Reference: Copperwood Stage 2 TIA – Comment Responses

**COPPERWOOD STAGE 2
TRANSPORTATION IMPACT ASSESSMENT**

DAYTONA URBAN DEVELOPMENT CORP.
City of Lethbridge RELD
COPPERWOOD STAGE II OUTLINE PLAN

Figure 3.7
Copperwood Stage 1 Volumes
AM Peak Hour
(From Copperwood TIA Figure 4.1)

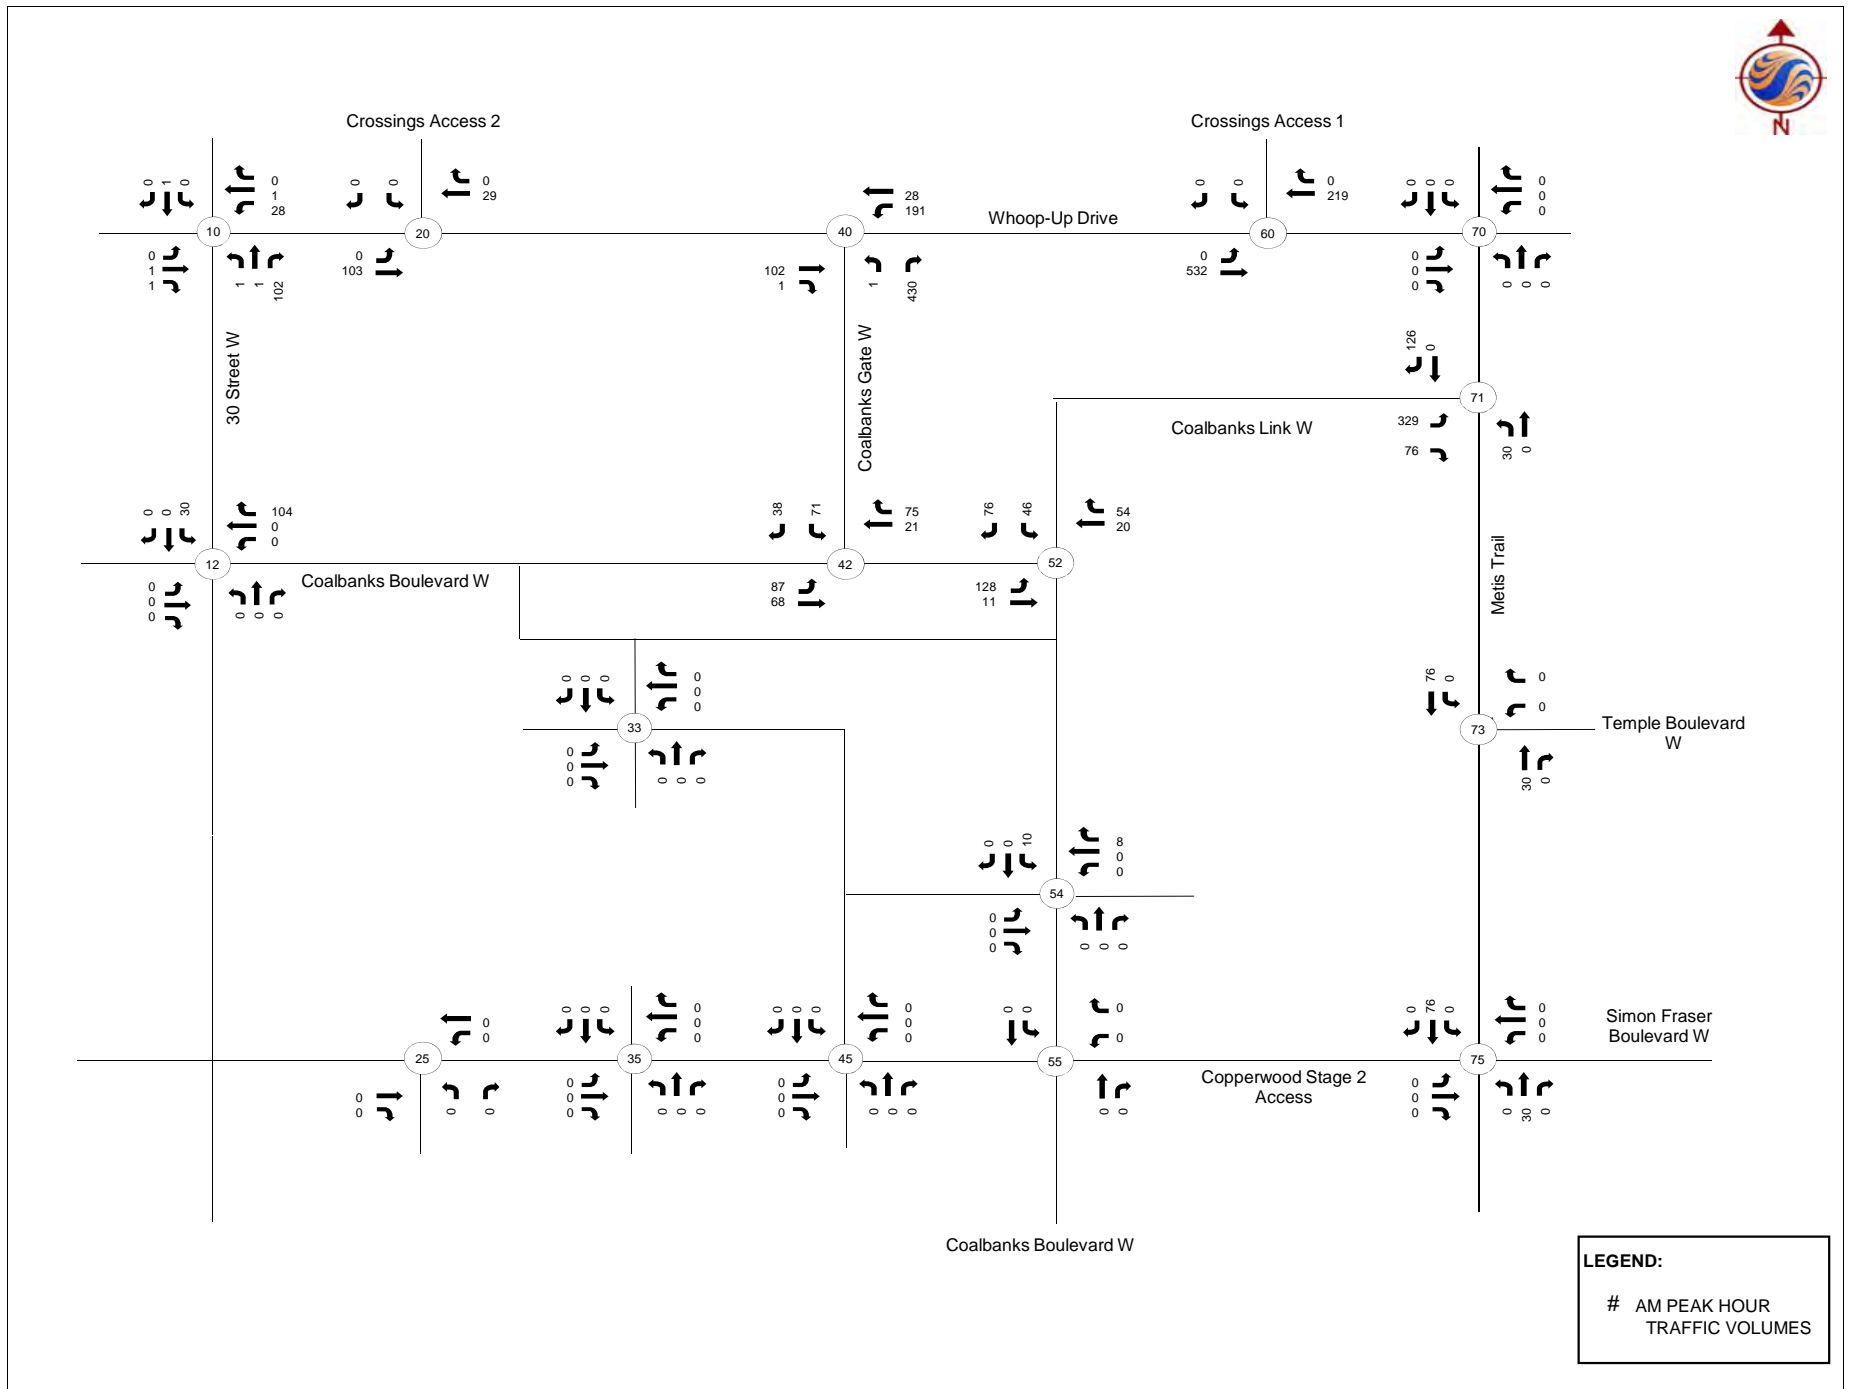
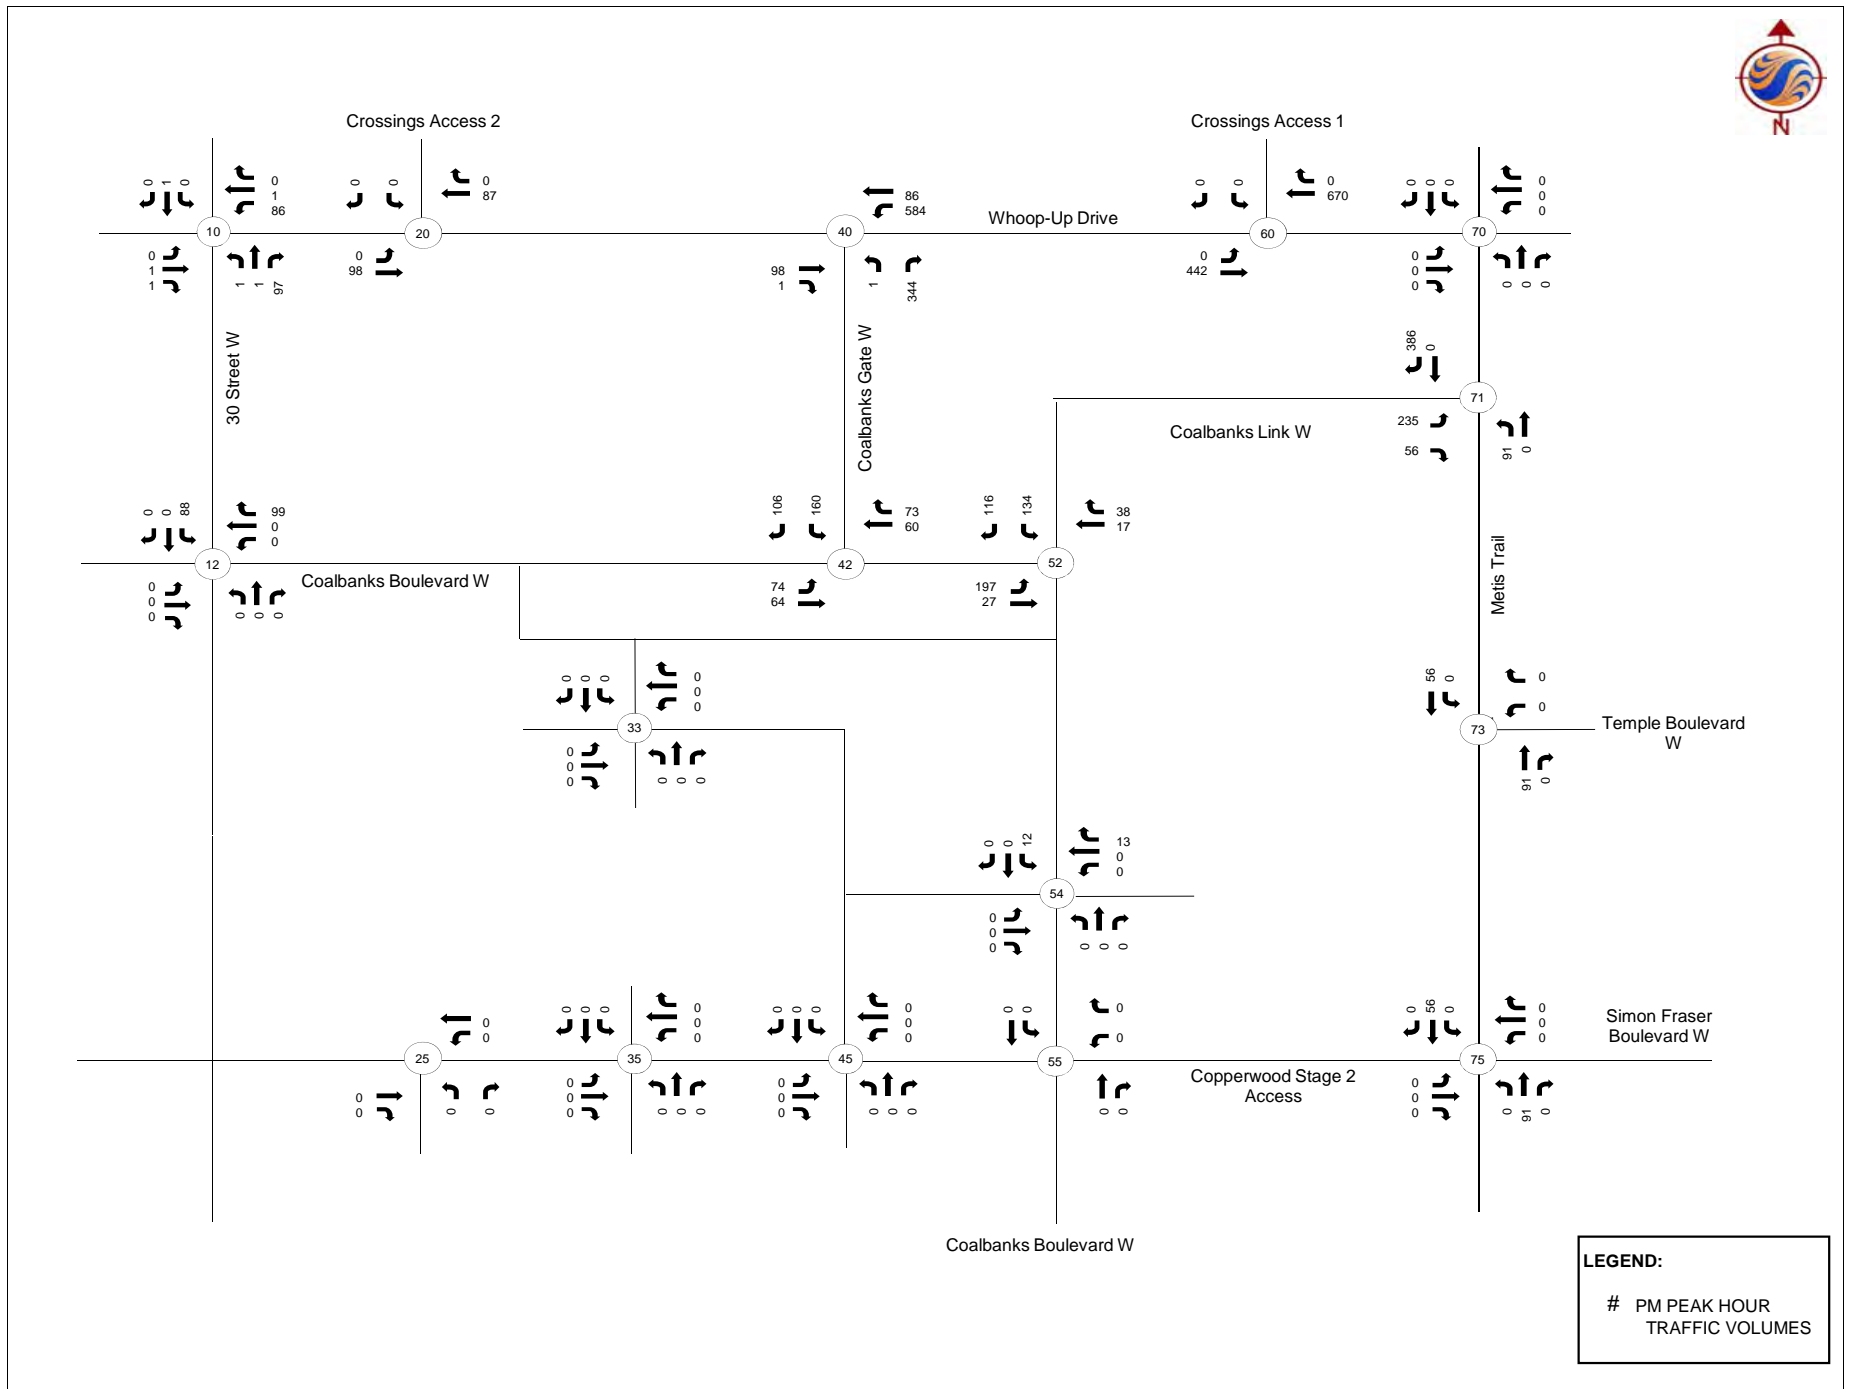
3. City’s Comment: *Figure 3.1 to 3.8 – Traffic volumes do not add up at Whoop-up Dr / Metis trail (Intersection 70), please check.*

Response: Figures 3.1 to 3.10 include information obtained from other studies (specifically the Crossings TIA – iTrans, July 2007; and the original Copperwood TIA – UMA, December 2005). These studies did not include volumes at the intersection of Whoop Up Drive / Metis Trail (Intersection 70) and therefore Figures 3.1 to 3.10 also did not include volumes at this intersection.

These volumes have been added to the updated report and are reflected in Figures 3.11 and 3.12 (background traffic volume), as well as Figures 3.15 and 3.16 which use the volumes from Figures 3.11 and 3.12 as information. The analyses for the background and post-development horizons have also been updated to include these volumes.

Figure 4.2
Copperwood Stage 2
Post-Development
Recommended Lane Configurations

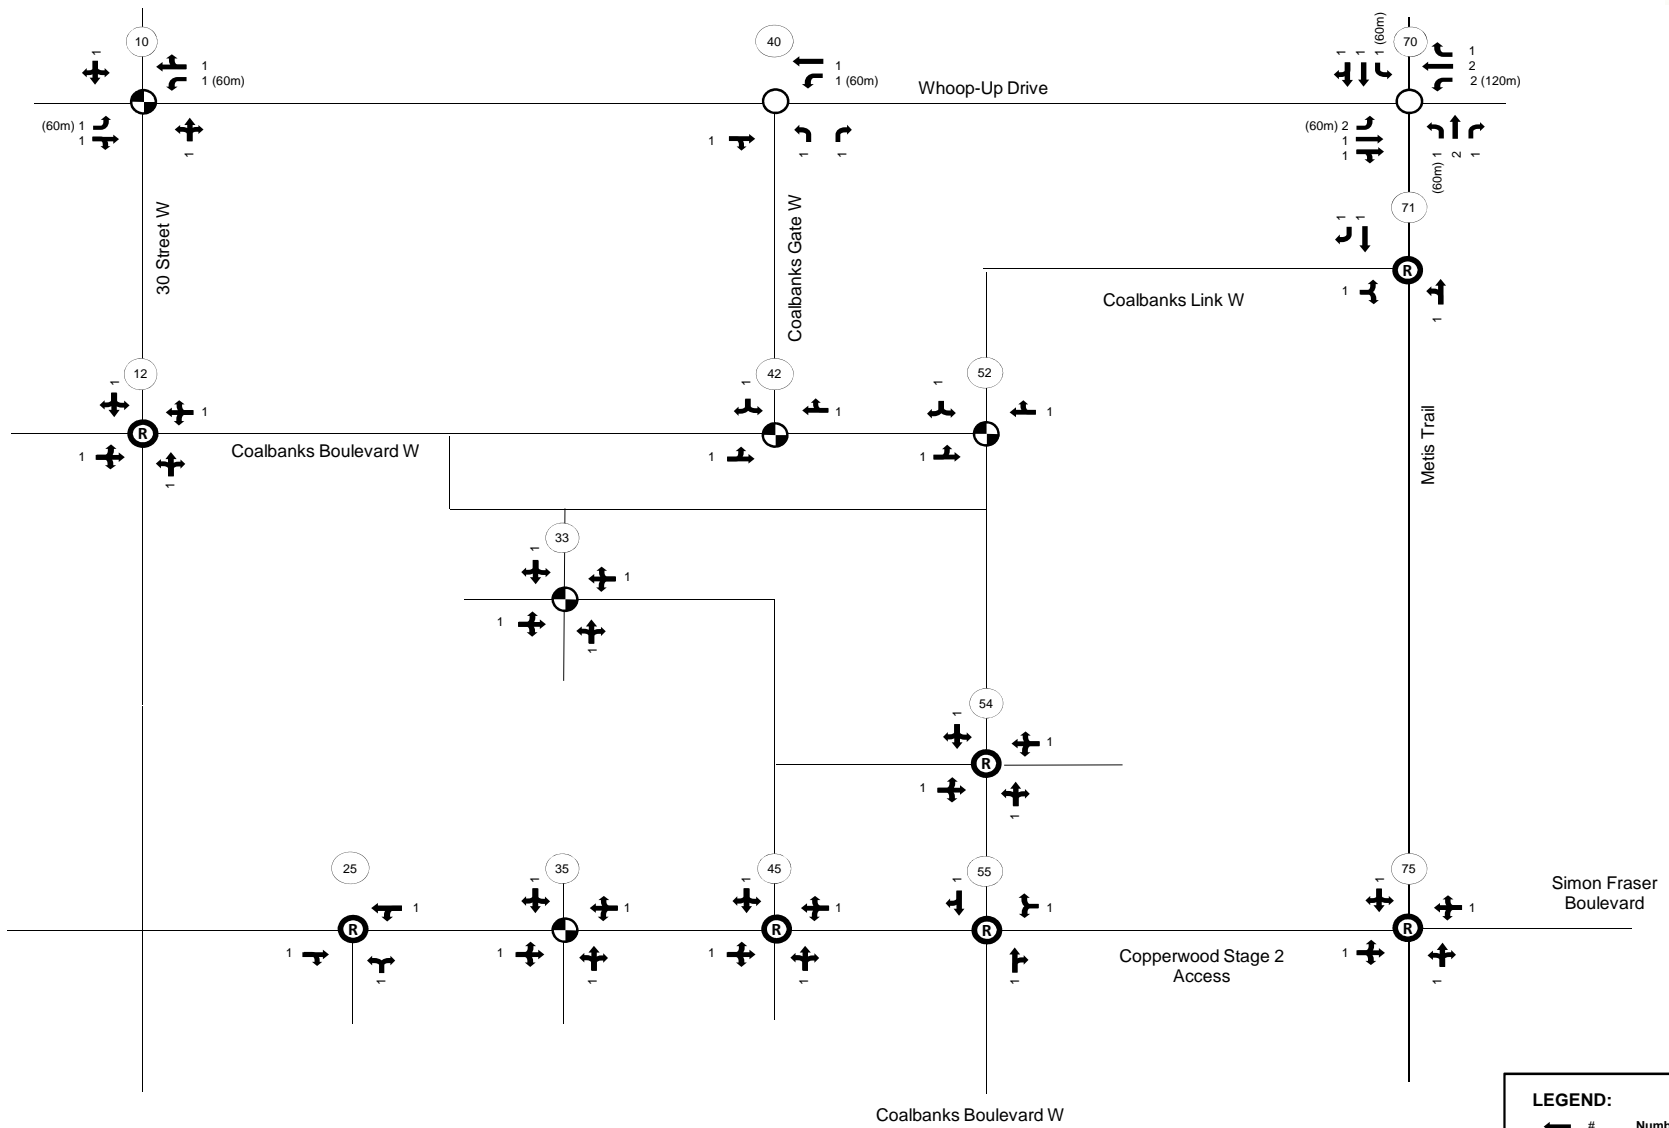
5. City's Comment: *Figure 4.2 –page 4.3: Please analyze Metis Trail/Coalbanks Link W as a 2 lane roundabout intersection.*

Response: The report has been updated to provide the results for all three intersections as both conventional intersections as well as roundabouts. Similar to the original report, the existing intersection (Metis Trail/Coalbanks Link W) has been analyzed for both the background and post-development horizons.
